EM-T-MOBILE-083-220722 T-Mobile Site ID CTHA537A 67 Fairchild Road Middletown, CT Notice of Compliance with Conditions and Construction Completion

Subject: **Post Construction Inspection Report**

Site Data:	67 Fairchild Road, Middletown, Middlesex County, CT 06457 Latitude <i>41 ° 32' 42.00"</i> , Longitude <i>-72 ° 37' 14.88"</i> 130 Foot – Monopole Tower	
Engineering Firm Designation:	TEP Project Number:	323470.794663
NE Site Solutions Designation:	Site Name:	CTNA537A
T-Mobile Designation:	Site Number: Site Name:	CTNA537A SBA Middletown Monopole

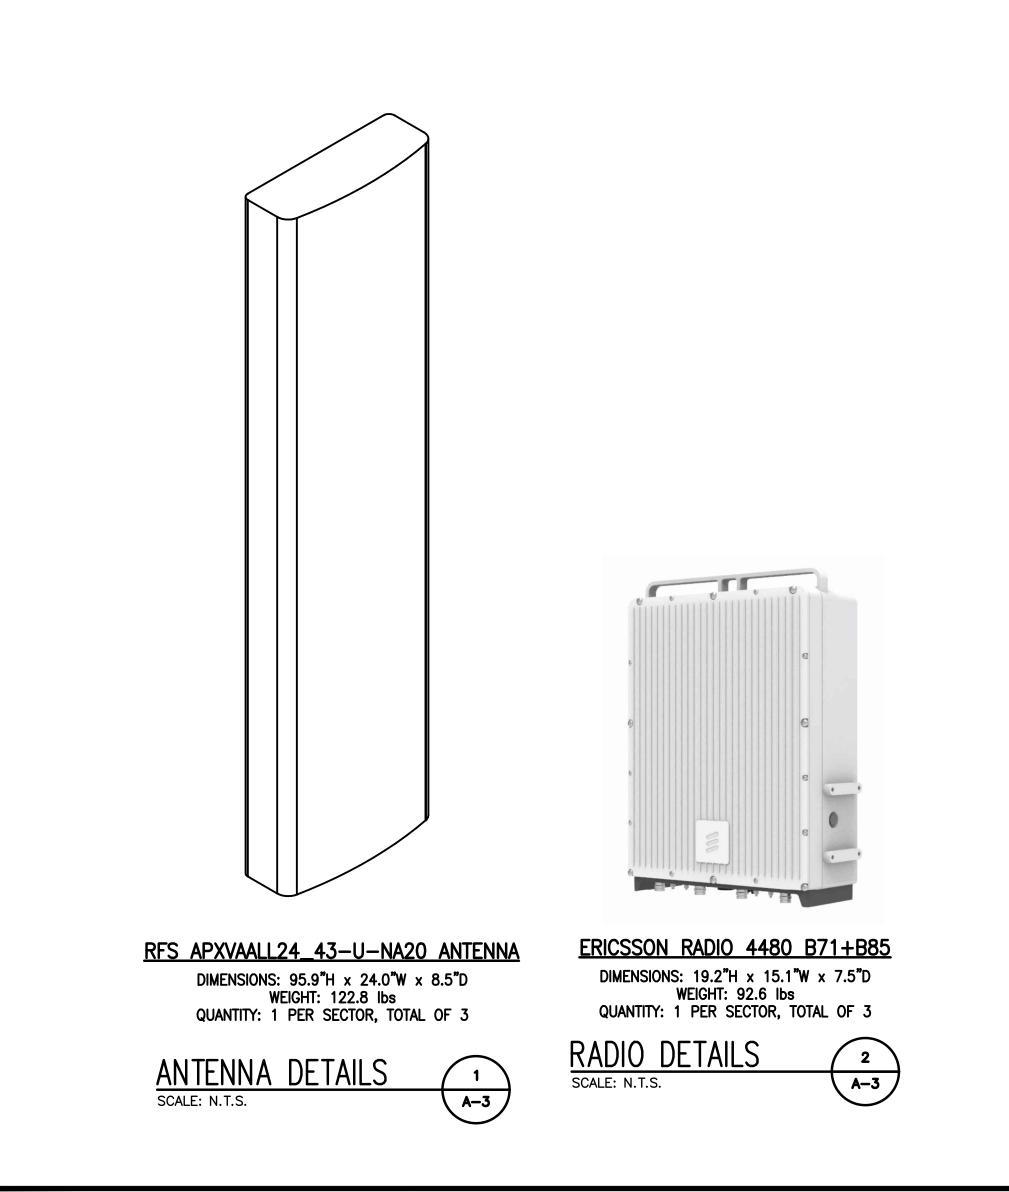
Photograph	Observations and Recommendations
	Item 1: Observation: The existing (6) 1-5/8°Ø coax cables to remain were observed to be cut at the base of the tower. Recommendation: Cut feedlines were removed from the tower. This change is redlined in the Construction drawings. See Appendix A. See Appendix A.

FE	EDLINE SCHEDULE	
SCHEDULE		FEEDLINES	LOCATION
A	EXISTING TO REMAIN: EXISTING TO BE REMOVED:	 (1) ¹/₂" COAX CABLE FOR GPS ANTENNA (6) 1-5% ø COAX CABLES *Dead coax was removed from the tower* 	ROUTED PER STRUCTURAL
В	PROPOSED:	(3) 2" (6x24) HCS FIBER CABLES	ANALYSIS
	BILE EQUIPMENT FEEDLINI LEMENTS MAY DIFFER.	E INVENTORY BASED ON OBSERVED FIELD CONDITIONS. RFDS	S AND FEEDLINE
